Addendum #4

Fire Truck Building at Woodville Training Site (WTS), T2 R9 TWP, Maine Project No. 23TC21-503-D, Bid #23-001

9 August 2022

SHEET ID:
A-203
 SHEET: 16 OF 37

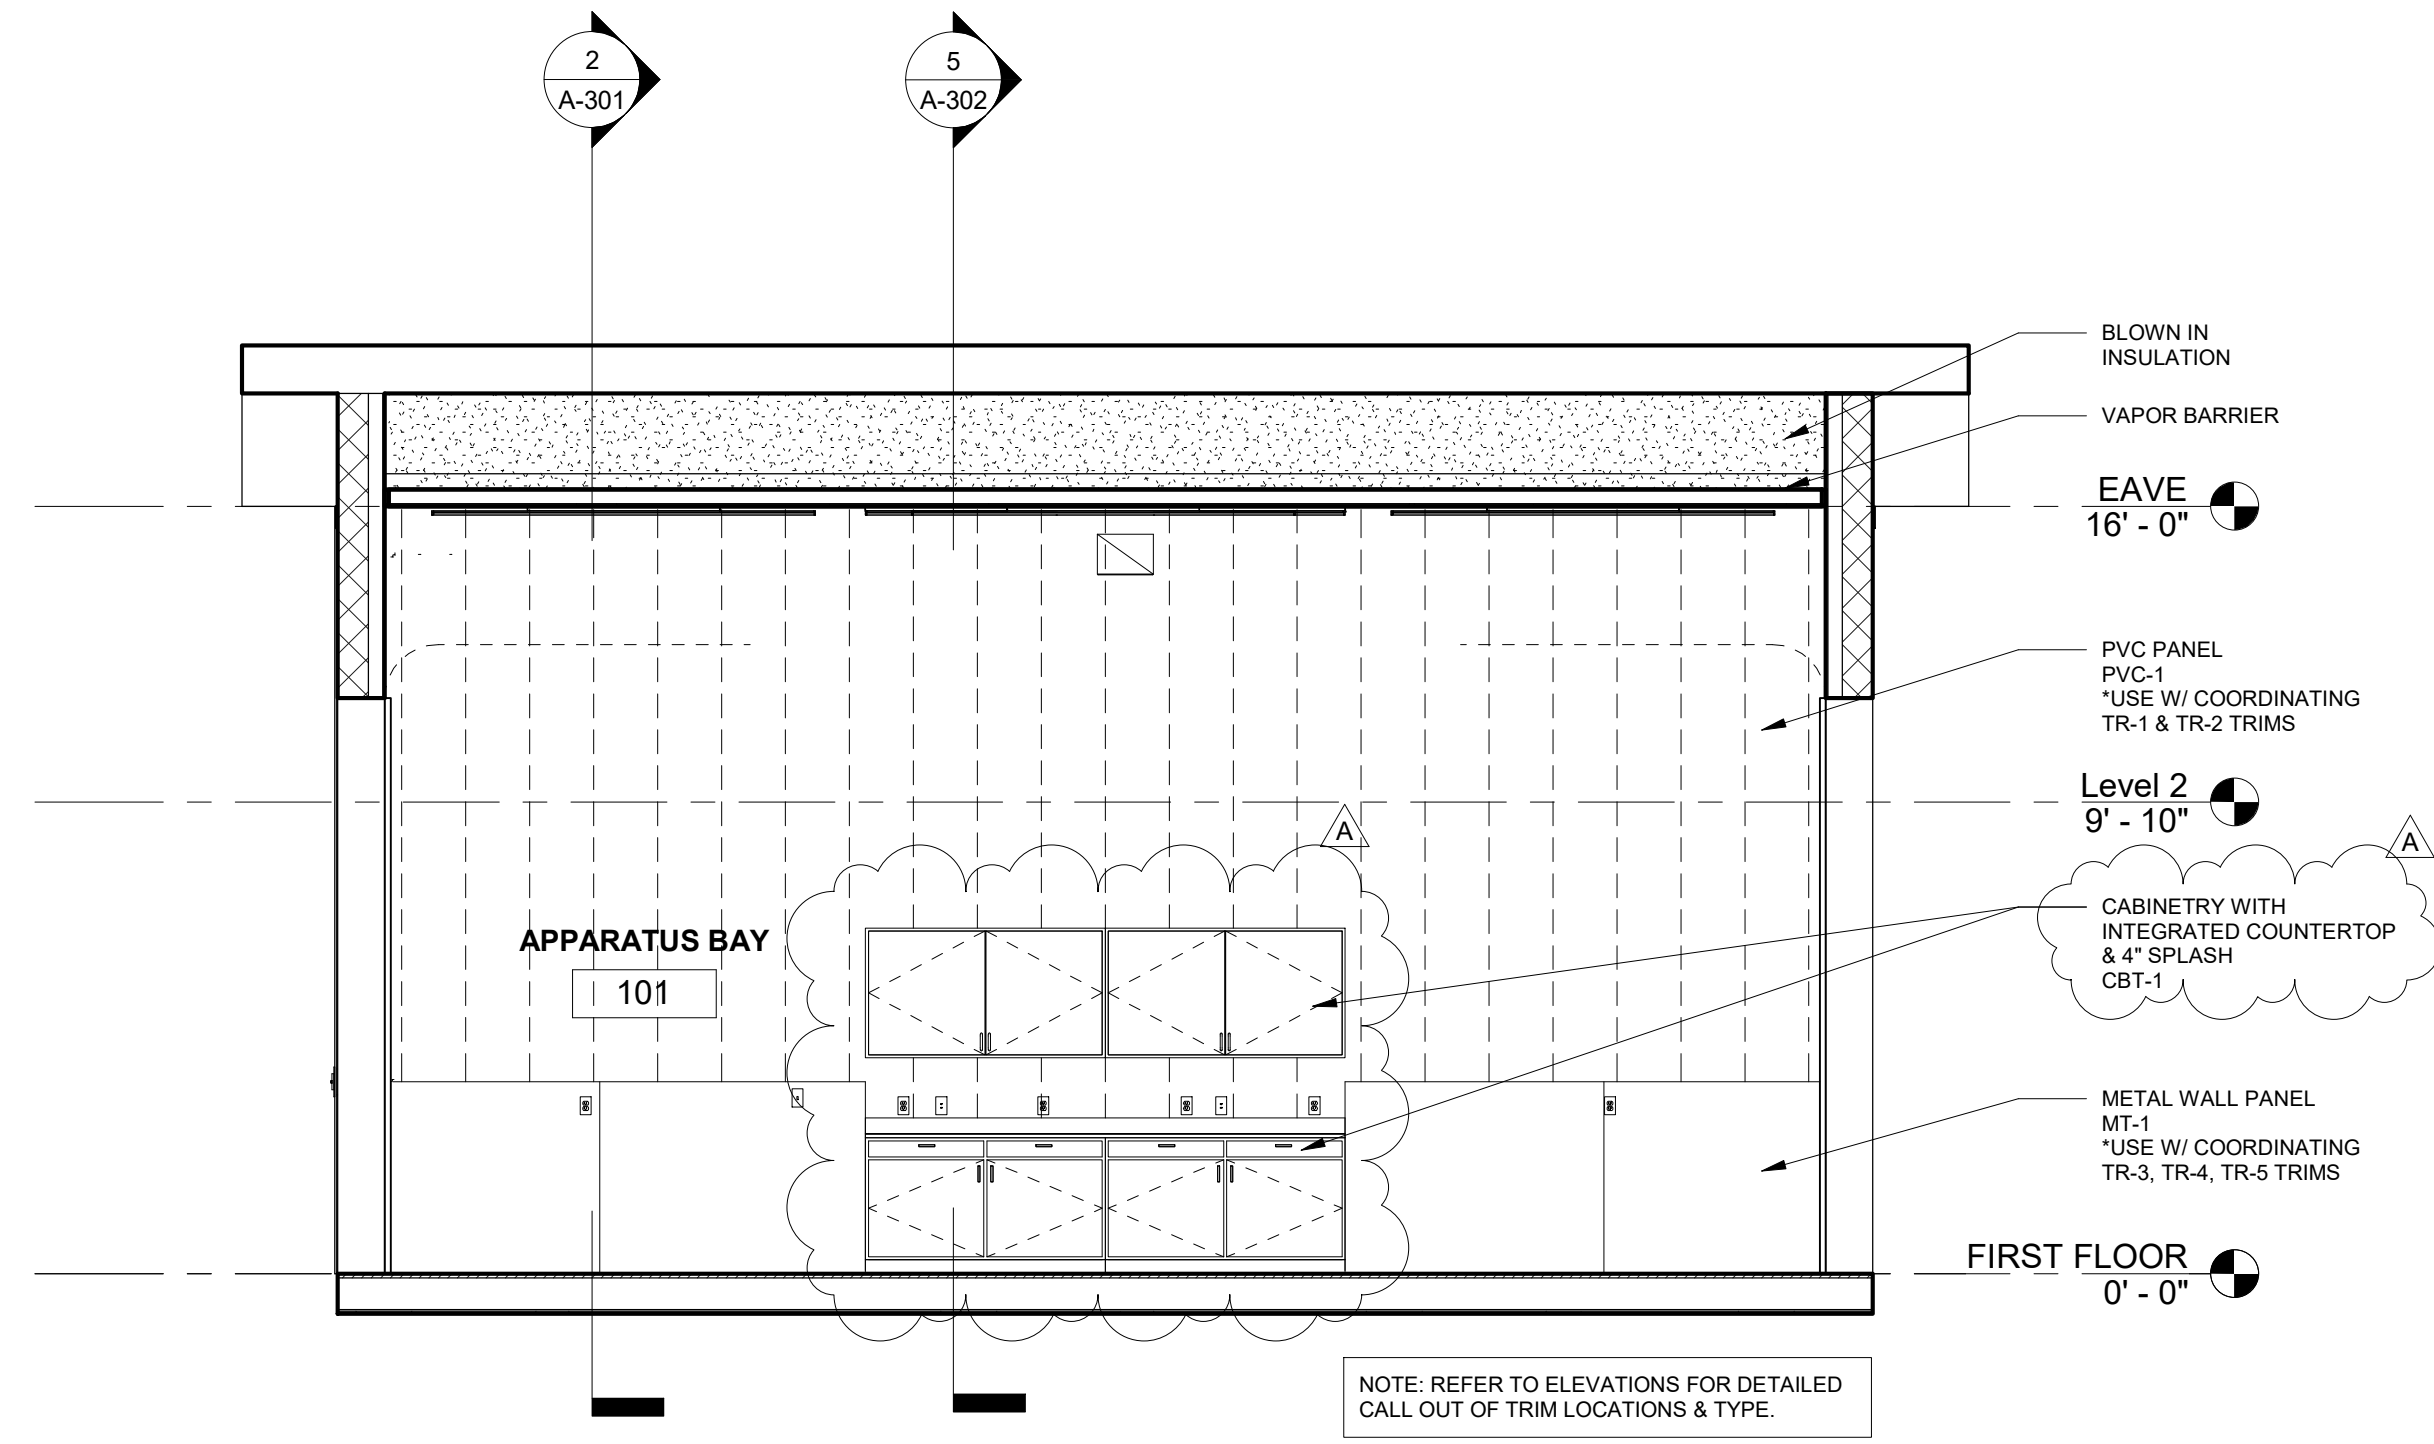
- Drawing A-203 shows handrail at ladder and mezzanine overhang. Is this to be fabricated and installed by contractor? If so, please provide a detail for this.

- To be fabricated, Structural to add handrail detail and drawings, top and middle rail and kickplate.
- Roof Eave detail shows Fiber cement board soffit. James Hardie makes a soffit panel. Is this what you are looking for or are you looking for cement board panels with separate continuous vent?

2 SECTION - WEST TO EAST
 A-301 SCALE: 1/4" = 1'-0"

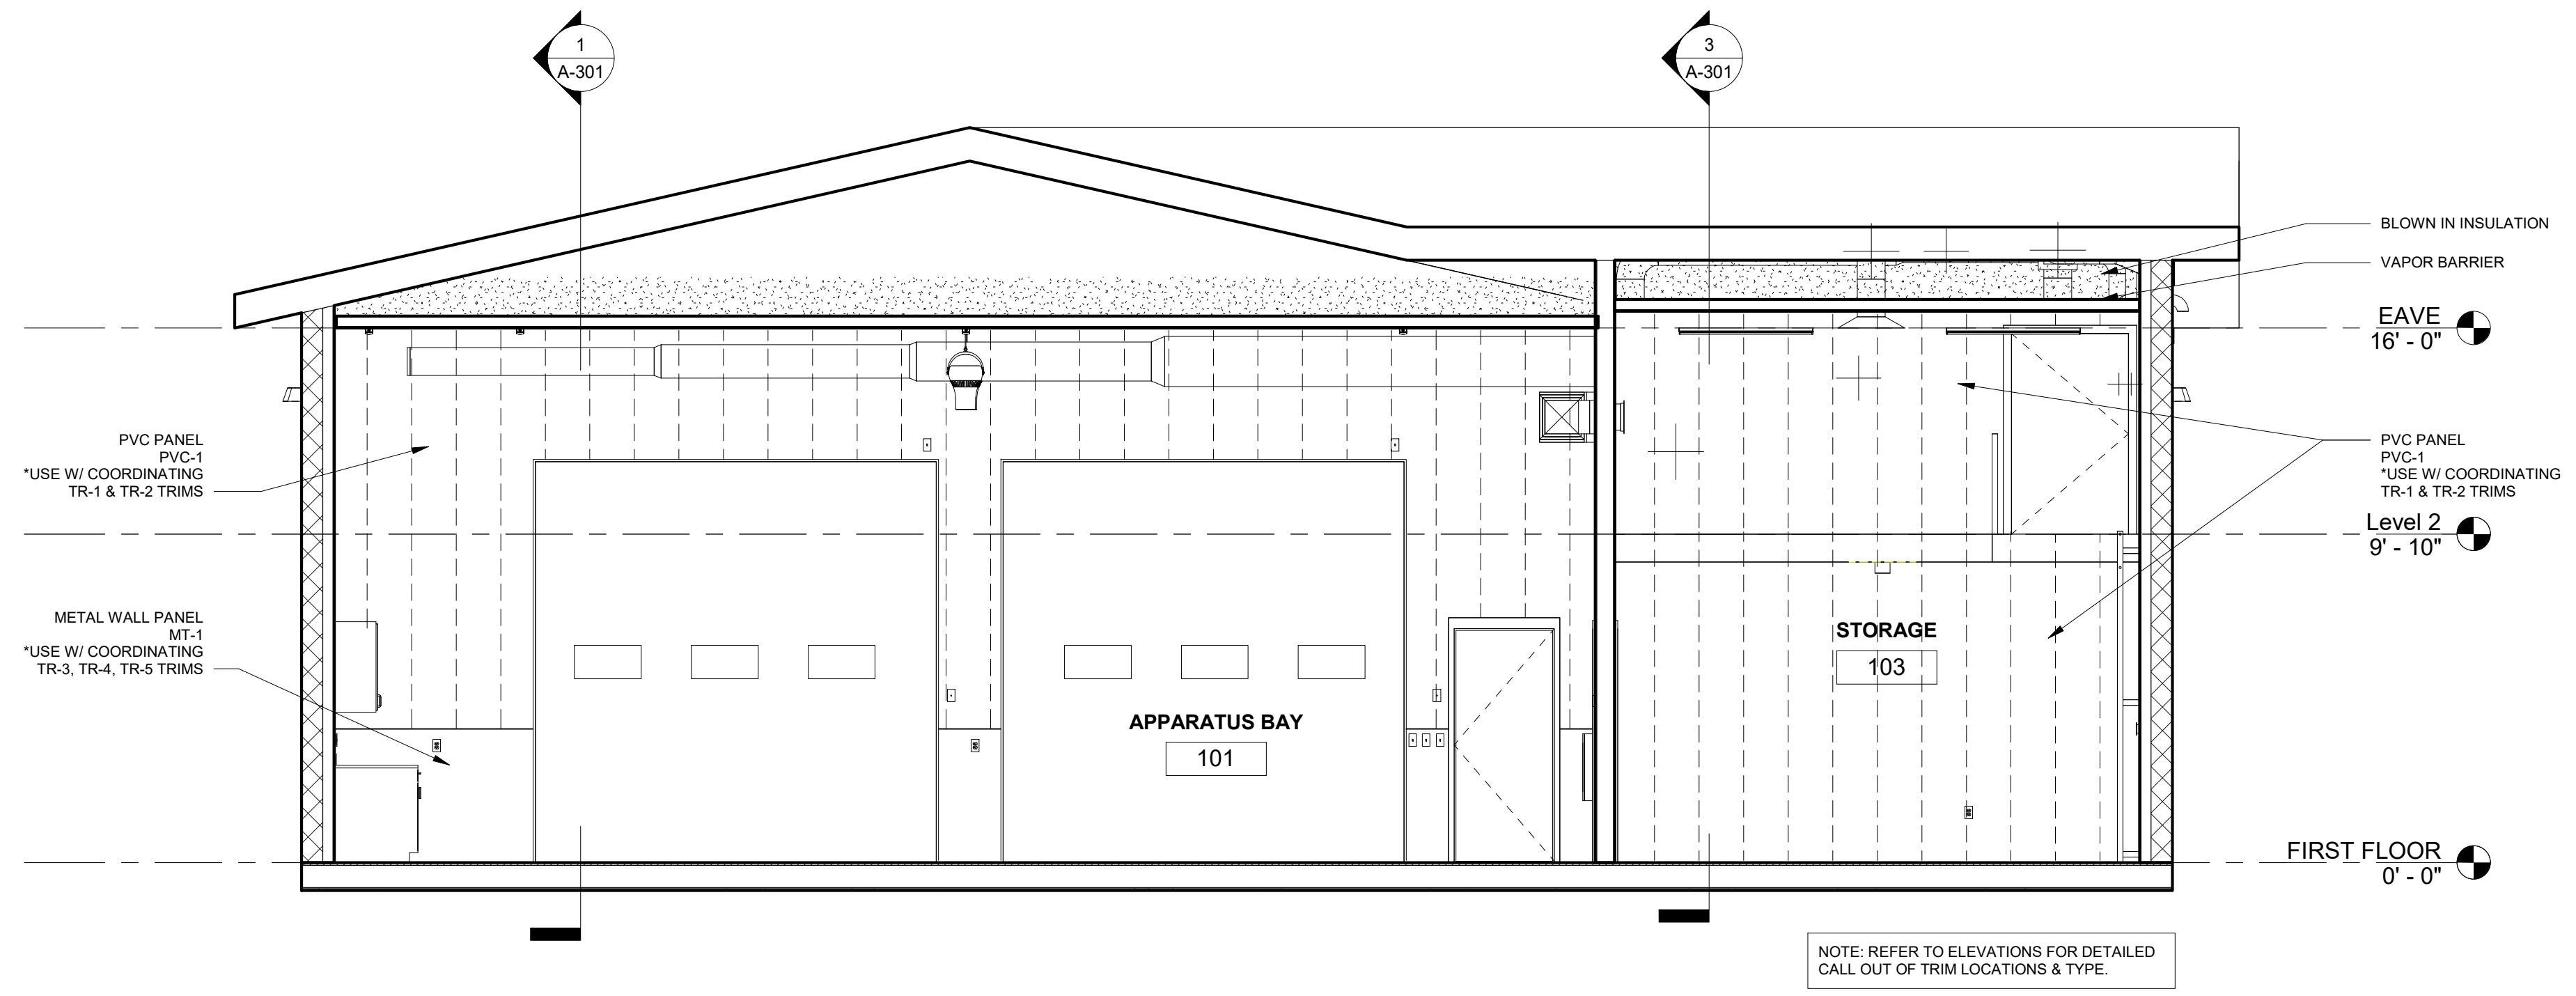
- Drawing A-301 appears to show a concrete deck for the mezzanine but there does not appear to be a detail in the drawings. I assume this is only a fire rated plywood decking with no concrete but please confirm.

- Correct, fire rated plywood decking no concrete, ¾” fire rated sheathing, 8” structural metal framing. Arch to update hatch and add note to drawings to clarify.
